OYSTER CREEK NUCLEAR GENERATING STATION, UNIT NO. 1

Amendment No. 46  
License No. DPR-16

ATTACHMENT TO LICENSE AMENDMENT NO. 46

SAFETY EVALUATION BY THE OFFICE OF NUCLEAR REACTOR REGULATION

FIGURE 3.5-1

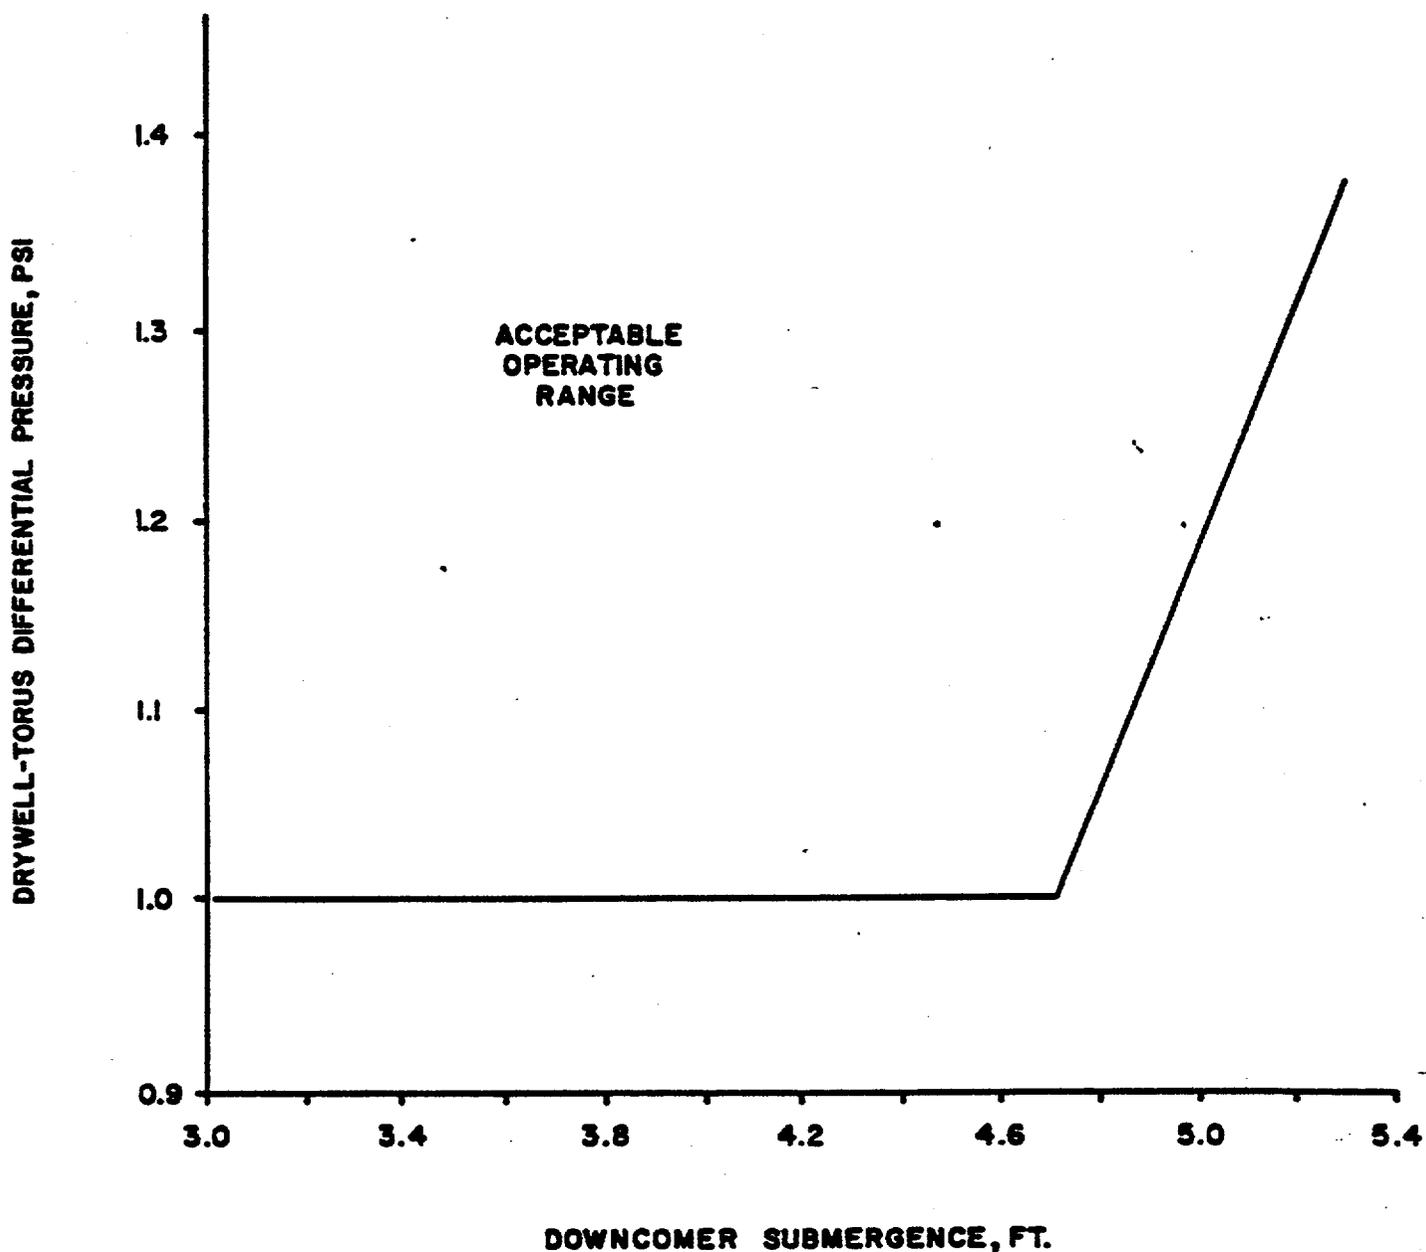
This amendment allows a minimum suppression chamber downcomer submergence of three feet and is a result of the Mark I Containment Long Term Program.

\*The actual acceptable range of downcomer submergence is governed by the Technical Specifications limit on maximum and minimum water volume in the torus (see section 3.5.A.1). This actual acceptable range of downcomer submergence will not encompass the full range of downcomer submergence indicated in the figure above.

Based on this assessment, we conclude that a minimum initial downcomer submergence of three feet is acceptable, and there is sufficient conservatism in the containment response analysis techniques to accommodate the effects of thermal stratification. Therefore, we find the proposed technical specifications acceptable.
